Office Action Summary

09/857,204

KELSO ET AL.

- 1) ☒ Responsive to communication(s) filed on 04 June 2003.
- 2a) ☒ This action is **FINAL**. 2b) ☐ This action is non-final.
- 3) ☐ Since this application is in condition for allowance except for formal matters, prosecution as to the merits is closed in accordance with the practice under *Ex parte Quayle*, 1935 C.D. 11, 453 O.G. 213.

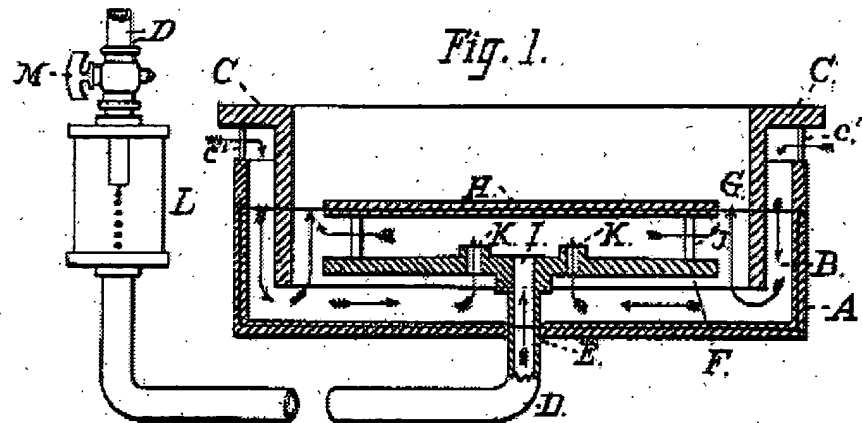
11. Regarding rejections based upon the reference Patterson ('068), applicant apparently desires that only the space between plates "H" and "F" of the reference be considered a chamber. While the examiner agrees that the space defined by these plates is a chamber, a device is not limited to having a single chamber. Chambers may be within other chambers. A chamber may be divided into plural sub-chambers. It is noted that the instant specification contemplates a divider being in the "chamber" (see page 7, lines 8 and 9 and claim 21). Therefore, the space including that between plate "H" and the bottom wall of "A" (having hole "E" through which "D" extends) may also be properly considered a chamber, even though it may also be considered divided into one or more sub-chambers such as the space between "H" and "F". An example of what may be considered a chamber of Patterson ('068) in accordance with the rejection of claim 1, is illustrated below:

It is clear that considering that which is mark in red above to be a "chamber" is completely consistent with the usage of the word "chamber" in the instant specification. Compare the above to, for example, instant Figs. 4 and 9(a)-(c). Applicant states "if the Official Action is asserting that the 'chamber' is define by F,G and H"; however, as illustrated above, "G" is a divider within what is considered "the chamber". As explained in this and the previous office action, the mixed fluid outlet is considered to be between "H" and "G". This is consistent with the intended use depicted by Patterson ('068) using arrows in Fig. 1 of the reference.
